### SCHEDULE OF SUBMISSIONS

No.	Name and Address	Summary of Submission	Officer Comment
1.	P D Wagg 28 Matheson Road Ascot WA 6104	1) Notes the residential and stables area's unique village style horse racing, stabling and residential character. Raises concerns and is not supportive of the potential redevelopment of Perth Racing's land. Outlines that if this occurs, that this would end racing in the area.	1) The draft Golden Gateway Local Structure Plan is not proposing the redevelopment of Perth Racing's land however it does identify alternative zoning for their landholdings. If Perth Racing chooses to redevelop, a development application will need to be submitted for assessment and demonstrate how Ascot Racecourse will operate.

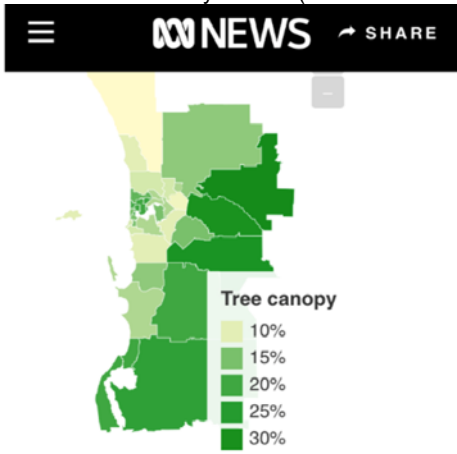
27.	B. Farrugia 4 Laser Close Ascot WA 6104	<p>2) Annotatable building height plan provided.</p> <p>1) Outlines being informed that the area near the Marina would be a coffee shop however notes that this has been developed into an apartment block. Highlights never being consulted on this development by the City of Belmont, only by the landowners.</p> <p>2) Questions where visitors will park if high rise buildings are developed.</p> <p>3) Notes that there are only three exits out of Ascot Waters and questions what will happen in an emergency if everyone was required to leave.</p> <p>4) Highlights existing peak hour traffic issues, in particular when trying to exit Ascot Waters. Considers that if additional high rise is developed within the estate that this issue will be further exacerbated.</p> <p>5) Considers that high rise development should be located along Great Eastern Highway.</p> <p>6) Concerns in relation to visual privacy as a result of high rise development being located in close proximity to existing houses.</p> <p>7) Concerned that views to surrounding parklands will be obstructed.</p> <p>8) Concerns in relation to increased noise levels.</p> <p>9) Concerns in relation to the draft Golden Gateway Local Structure Plan impacting upon the amenity of the Ascot Waters area.</p>	<p>2) Refer to comments under the heading Residential Density &amp; Built Form Control in the Officer Comment section of the report.</p> <p>1) The development located adjacent to the marina in Ascot Water Estate is not subject to the draft Local Structure Plan. Refer to discussion under the heading Proposed Activity Centre &amp; Retail Floorspace in the Officer Comment section of the report.</p> <p>2) Refer to discussion under the heading Car Parking in the Officer Comment section of the report.</p> <p>3) Refer to comments under the heading Ascot Waters Access &amp; Egress in the Officer Comment section of the report.</p> <p>4) Refer to comments under the heading Ascot Waters Access and Egress in the Officer Comment section of the report.</p> <p>5) Refer to comments under the heading Residential Density &amp; Built Form Control in the Officer Comment section of the report.</p> <p>6) Visual privacy will be considered as part of any development proposal.</p> <p>7) Existing parklands are not proposed to be removed and development is not intended to extend into these areas. It is unclear how redevelopment in this precinct could obstruct views for residents in Ascot Waters.</p> <p>8) There is no evidence to suggest that noise levels will increase within this area.</p> <p>9) There is no evidence to suggest that an increase in residential density or the proposed draft Local Structure Plan will impact upon amenity negatively. Any potential impact on amenity will be considered at the time of each individual development application to ensure that any impacts are reduced.</p>
